REGIONAL WATER QUALITY MANAGEMENT PLAN

CITY OF NEW BERLIN

SUBJECT: Certification of Amendment to the Adopted Regional Water Quality Management Plan (New Berlin Sanitary Sewer Service Area)

RESPONSE TO REQUEST BY THE CITY OF NEW BERLIN TO AMEND THE NEW BERLIN SANITARY SEWER SERVICE AREA

PROPOSED AMENDMENT TO THE NEW BERLIN SANITARY SEWER SERVICE AREA

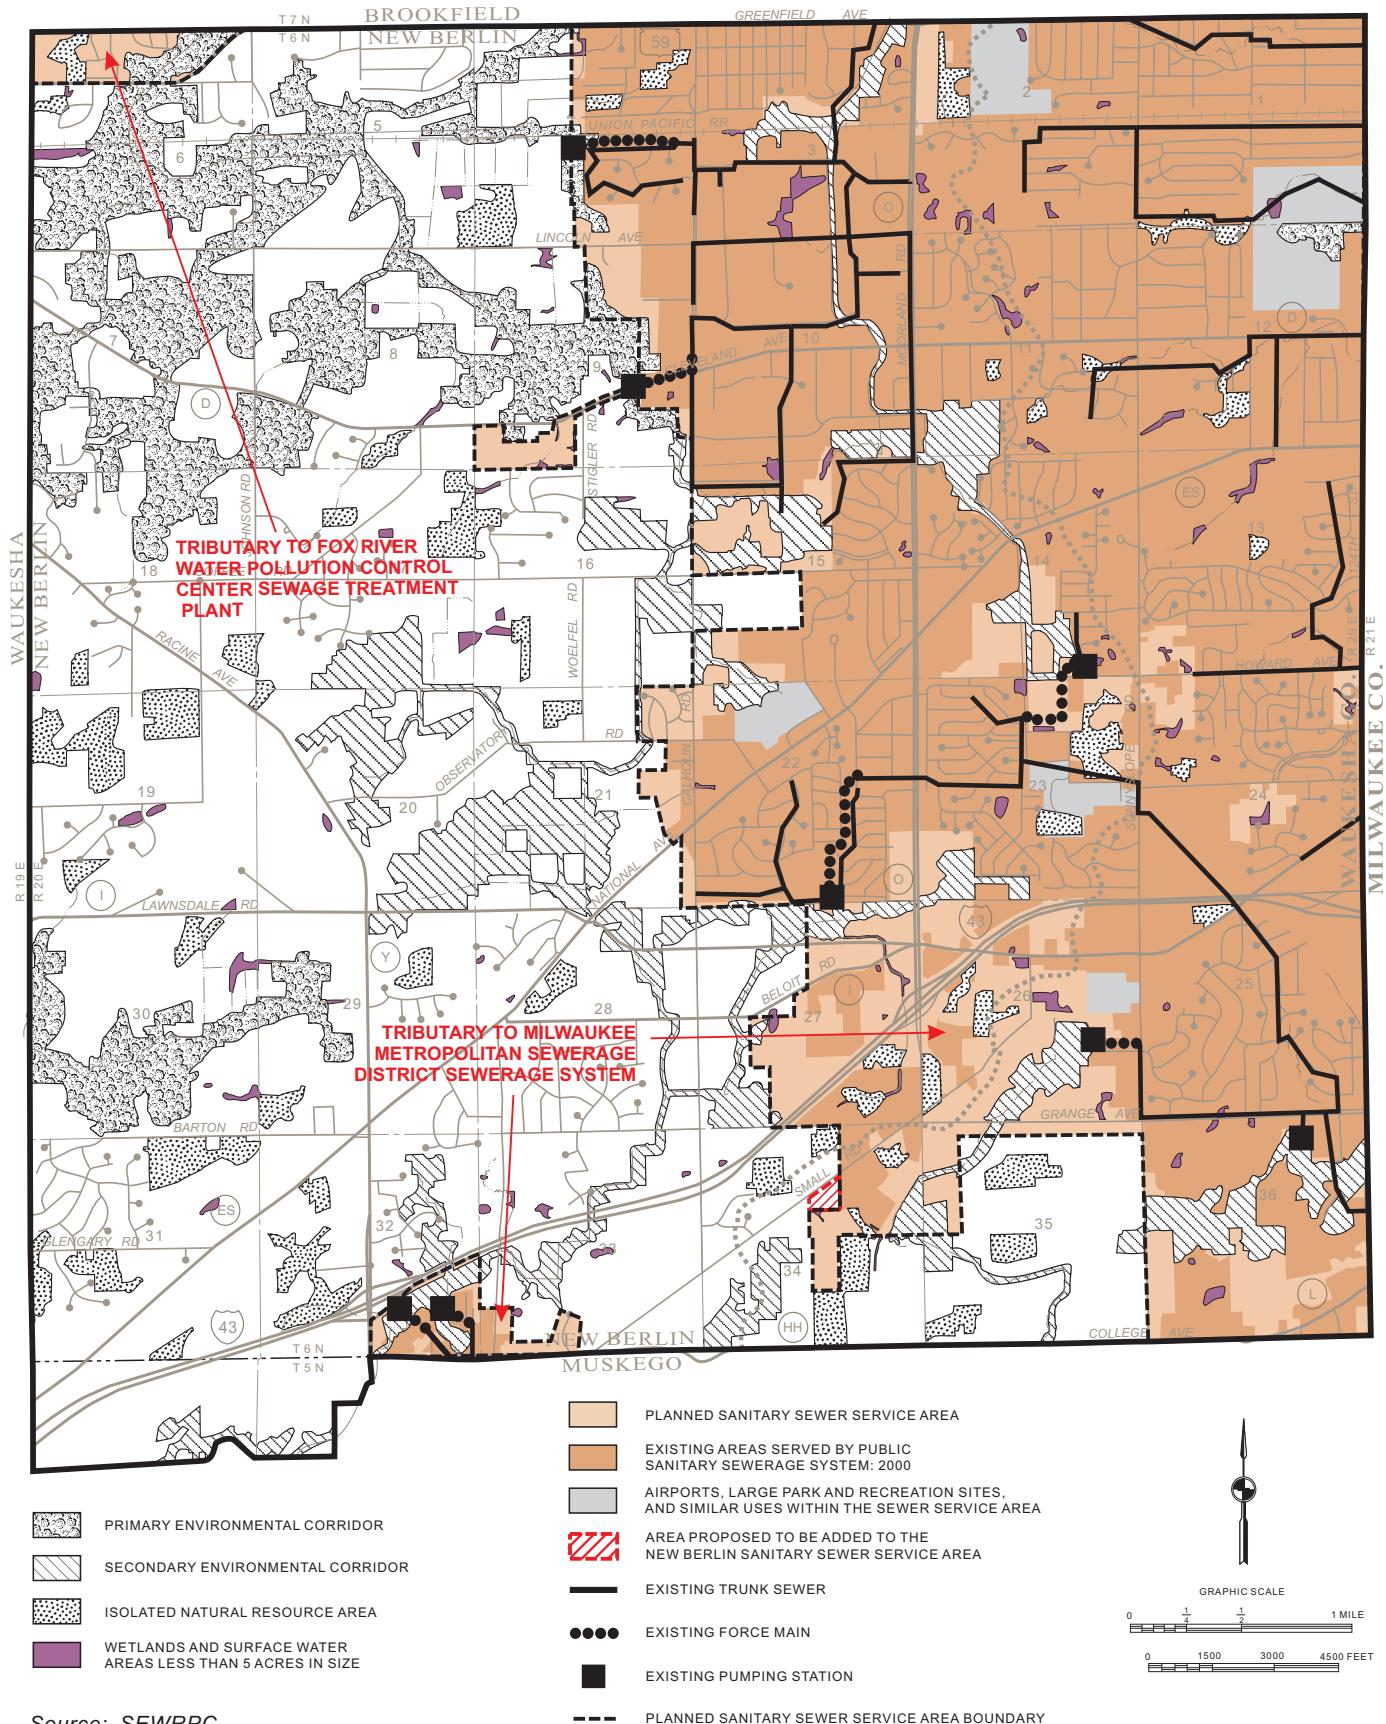
As shown on Maps 1 and 2, the area to be added to the sewer service area is a 7.7-acre parcel located at 16385 W. Small Road in the City of New Berlin. The parcel would be developed for warehouse and office use, serving as an expansion of the BuySeasons facility to the south. There are no environmental corridors or isolated natural resource areas on the property.

The proposed addition of 7.7 acres to the New Berlin sanitary sewer service area represents an increase in the planned sewer service area of less than 1 percent.

Based upon the foregoing, it is recommended that the Southeastern Wisconsin Regional Planning Commission formally amend the City of New Berlin sanitary sewer service area as documented in SEWRPC Community Assistance Planning Report No 157, in the manner shown on Map 1.
